**Item 5.****Development Application: 330 Botany Road, Alexandria - D/2021/1484****File No.:** D/2021/1484**Summary****Date of Submission:** 20 December 2021. Amended plans and additional information were submitted up until 29 May 2023.**Applicant/Developer/Owner:** City West Housing Pty Limited**Architect:** SJB Architects**Planning Consultant:** Ethos Urban**Cost of Works:** \$119,609,875**Zoning:** Zone E3 Productivity Support**Proposal Summary:** **Proposal**

The subject development application (DA) seeks consent for:

**Figure 44:** Typical detail of proposed attenuated natural ventilation plenum (source Natural Ventilation 330-332 Botany Road, Rev. C, 1 December 2022, Flux).

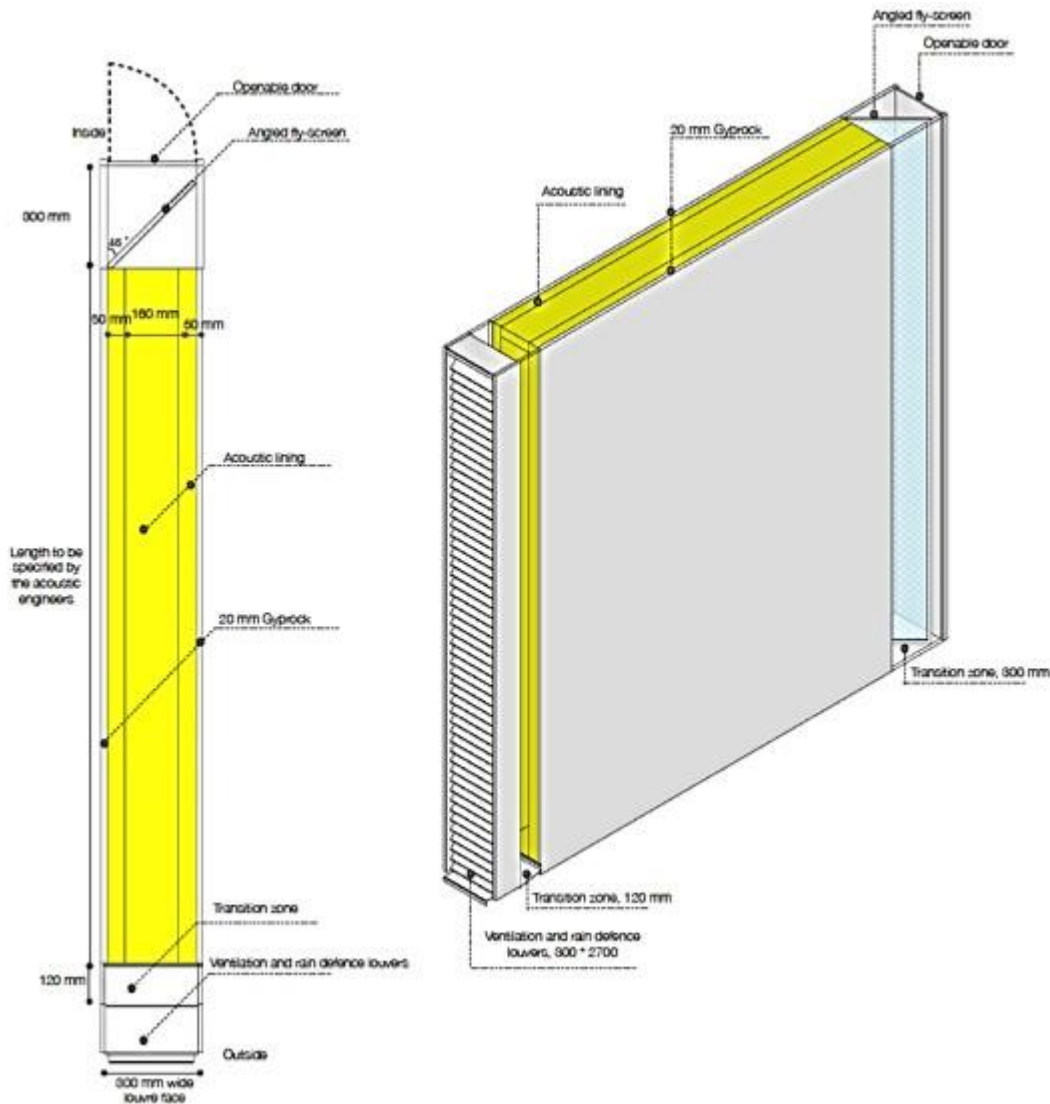
107. As shown in Figure 44 below, the Ventilation Report contains diagrams that illustrate the typical arrangement of a vertical plenum, excluding the structure. That is, it shows the 160mm clear plenum width, the 50mm acoustic linings and 20mm plasterboard to both sides of the plenum and which adds up to a width of 300mm in total. However, these diagrams and the spatial allowance within the reference scheme plans do not account for the outer structure and cladding of the plenums, particularly where they are located on an external wall.

108. Considering some of the plenums will be greater than 300mm wide, some of the rooms shown on the reference scheme plan would not achieve the minimum size requirements specified in the ADG (such as the 3m minimum width for a bedroom).
109. While this issue is to be addressed through the competitive design process and subsequent detailed design DA it may result in a reduction in achievable yield for the development. Design solutions to offset any impacts to yield may be explored through future competitive and detailed design processes

**Figure 45:** Illustration of corner apartments that have been included in the applicant's tally of naturally cross ventilated apartments.

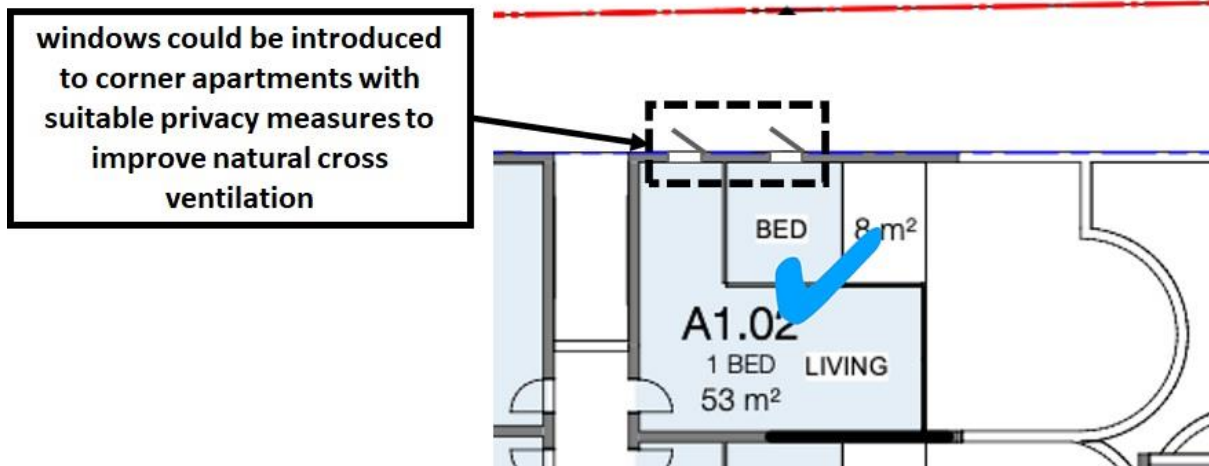
110. Forty-four percent (49 of 111) of non-noise affected apartments within the first nine-storeys of the reference scheme are naturally cross ventilated. This is counting the 8 apartments (AG.01 to A7.02) that are not naturally cross-ventilated, an example - apartment A1.02 - is shown in Figure 45 below, but which could easily incorporate a window in their northern elevations to be configured as corner, and therefore naturally cross ventilated, apartments.

111. The satisfaction of ADG objectives will need to be addressed through the competitive design process and subsequent detailed design DA by introducing windows as illustrated in Figure 45 below, as well as by introducing breaks in the building massing and which will likely result in a reduction in achievable development yield.

**Figure 46:** Public domain interface to GS2AC Road is to be improved through competitive and detailed design processes.

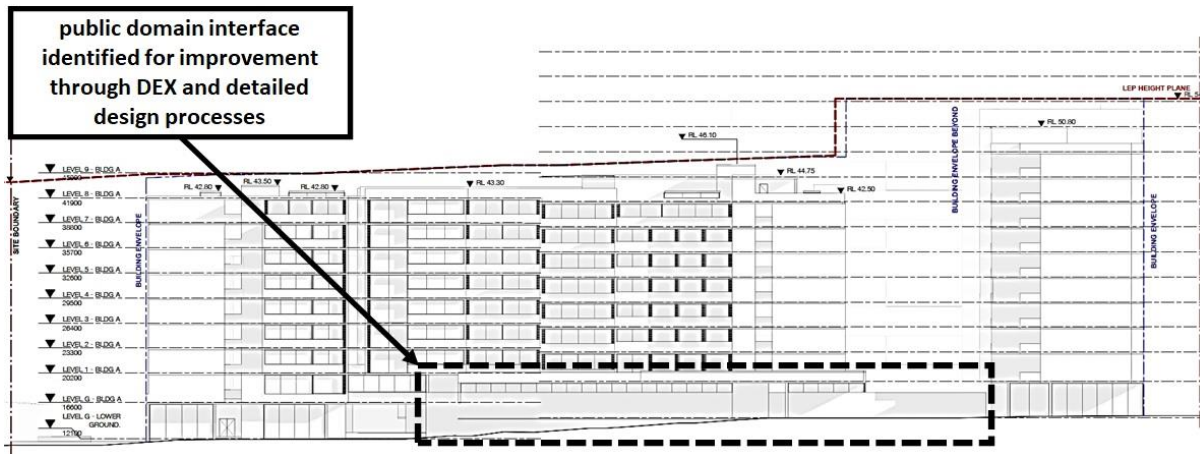
115. Previously, the site's Botany Road and O'Riordan Street frontages were identified as active frontages on the DCP's active frontages map.
116. As noted elsewhere in this report, the Enterprise Areas Review Planning Proposal made changes to mapped active frontage locations in North Alexandria. Now, the site's interface to the GS2AC Road is identified as an active frontage on the DCP's active frontages map.
117. The reference scheme demonstrates that the flood planning levels recommended in the site-specific flood planning assessment can be achieved. However, as shown in Figure 46 below, the southern elevation of the reference scheme features blank walls and a long series of ramps (over 40m in length) running parallel to the street and which reduce the activation of this frontage to the new GS2AC Road.

118. Conditions are recommended for design requirements to be included in any competitive design process brief for competitors to explore design solutions to:
- (a) minimise the difference between the internal ground floor level and the level of the public domain to avoid creating a physical barrier, such as steps or ramps, to the shop windows of commercial tenancies fronting the GS2AC Road;
  - (b) increase the portion of the ground floor that is close to being at grade with the footpath;
  - (c) maximise activation, visibility into and out of the commercial tenancies from the street; and
  - (d) maximise the number of direct entries to these tenancies from the street.

Figure 47: Recommended design modifications to accurately illustrate deep soil zones.

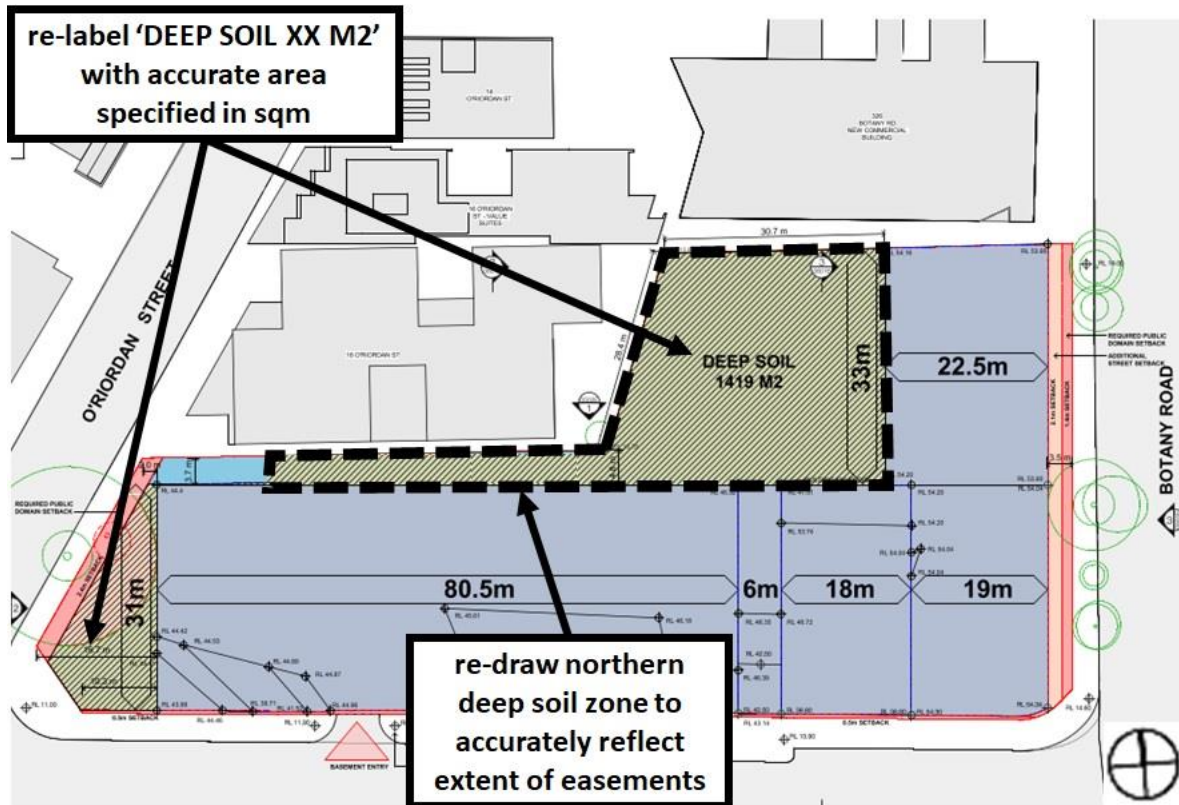
127. Conditions are recommended for the drawing titled Envelope - Site Plan (no. SK-0103E) to be amended as follows and as illustrated in Figure 47 below:

- (a) the narrow strip shaded in green and with black hatching to indicate deep soil and which is located between the envelope fronting the GS2AC Road and the northern boundary, is to be reconfigured to include that part of the area marked in light blue hatching to indicate 'Easement' that is to be redrawn to accurately reflect the configuration of the right of carriageway and easement for drainage that exist in the north-west corner of the site (i.e. the easement area will be reduced);

- (b) both of the deep soil zones are to be annotated as 'DEEP SOIL' and with the area of each deep soil zone specified in square metres;
  - (c) conditions are recommended for any structures in deep soil zones to be constructed of lightweight materials such as timber decking or water permeable paving to allow for filtration of rainwater into the ground.
